Jib Support Replacement (Effer — Campaign ID: CL202217)

Campaign id: CL202217

JIB support replacement

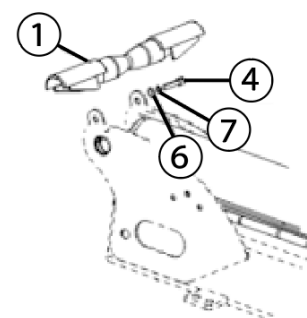
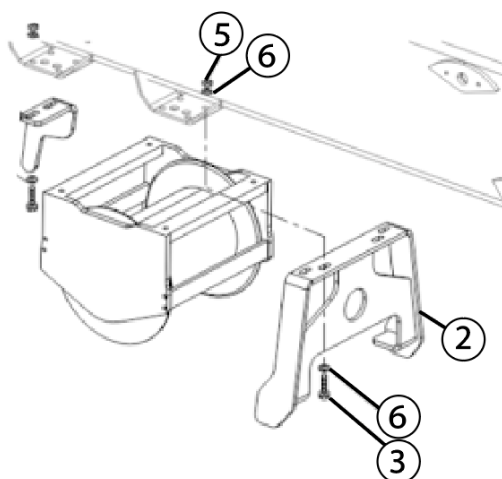
Based on information from the market, we found a problem with the JIB support in crane model EFFER 505. During the transport of the crane, we could see some bouncing movements of the JIB against its support. Thus, Effer R&D decided that in these cases it is necessary to replace the JIB support.

First, replace the JIB support.

N. in the picture	p/n
1	2K86121
2	5R86002
3	8229700GE
4	8263500GE
5	84080147
6	8521100GE
7	8526300GE

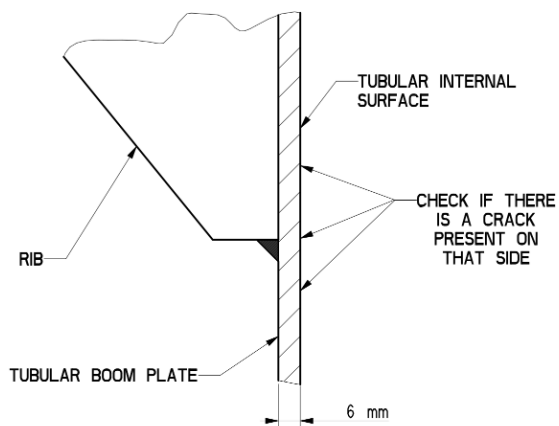
Then, check if there is any crack in the 2nd boom as shown in the following picture. If you find a crack, see the instruction below. If there is no crack, no preventive action is required.

Where the rib is welded to the tubular of the boom, the crack is probably on all the thickness of the tubular plate. If the crack is not visible to the unaided eye, perform an LPI (Liquid Penetrant Inspection) or similar test on the internal surface (Step 1 in the drawing below). If the crack is passing through the plate (so it is also in the internal surface), start to repair it by grinding from inside the boom (Steps 2, 3, 4, and 5 in the drawings below). If the crack is not inside, you can repair it only from the external side (Steps 4 and 5 in the drawings below).

Drawing 1

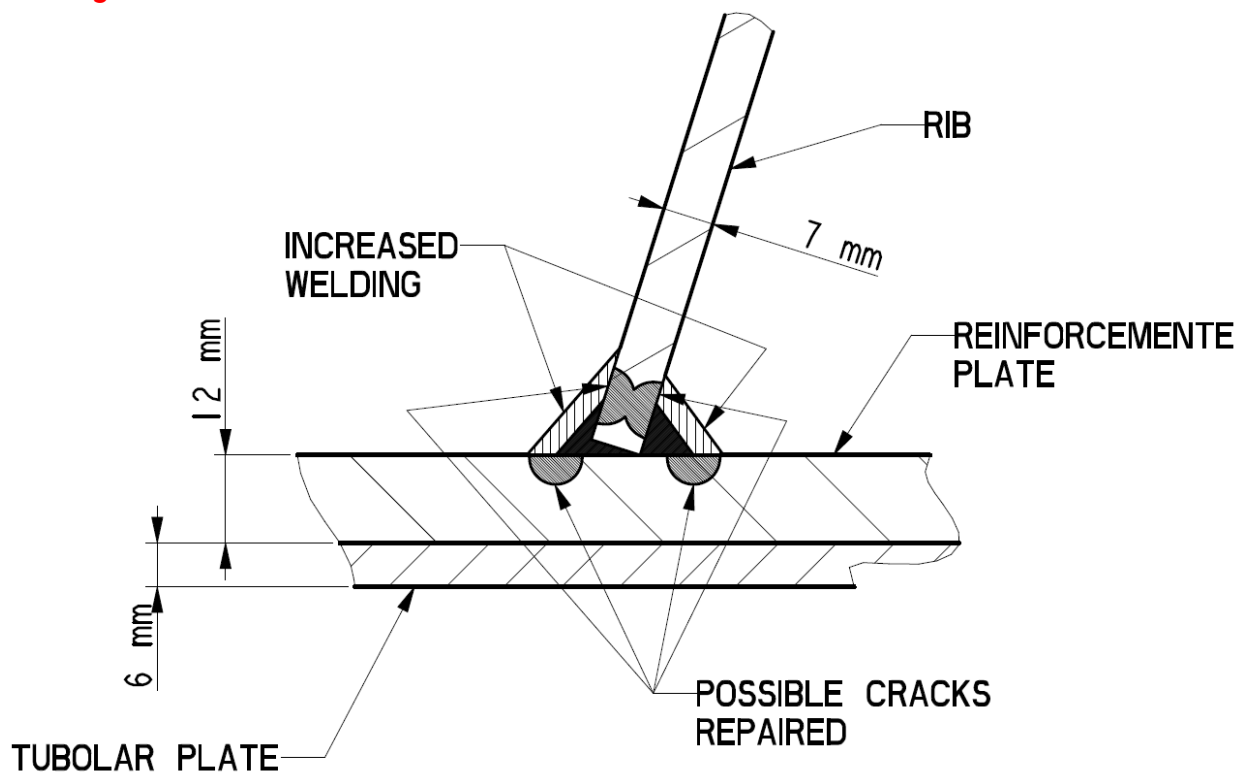
- After the crack is repaired, add an external reinforcement (e.g. 5R40370, Drawing 2 and 3) to make the repaired zone stronger.
Important! Make the reinforcement from a plate of S690QL or S700Mc with a thickness of 8 mm. The shape of the reinforcement is shown in **Drawing 2** below and must cover the repaired zone. Smooth at 30° the internal profile to get a good chamfer to weld it.
- For the rib on the reinforcement, if there is a crack on the reinforcement of 12 mm thickness, remove it by grinding and heating (**Drawing 1**).
- If the crack is on the rib with 7 mm of thickness, remove it, by heating and grinding on both sides. (**Drawing 1**).
- Increase the weld of the rib, anyway, about 40 mm to reinforce the end of the rib (**Drawing 2**):

Drawing 2

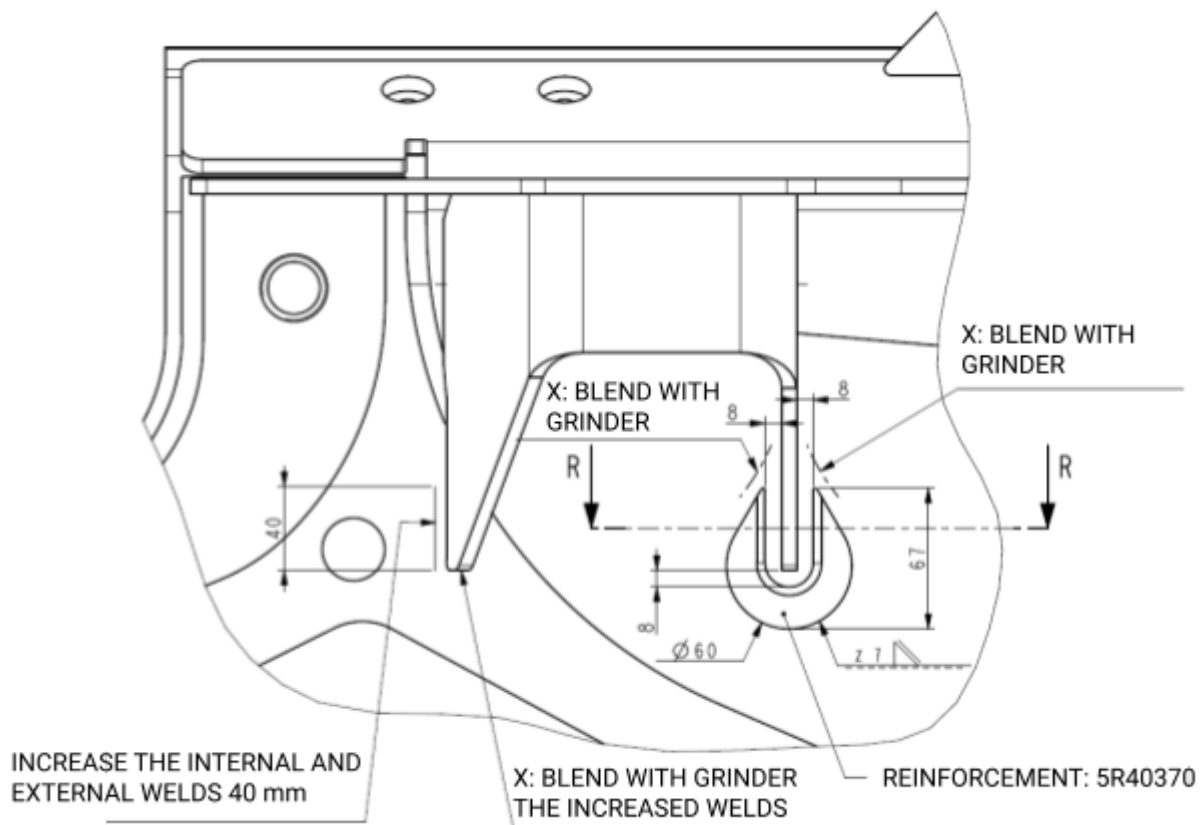
Important! Blend all the welds, in particular the point with "X" in the following picture:
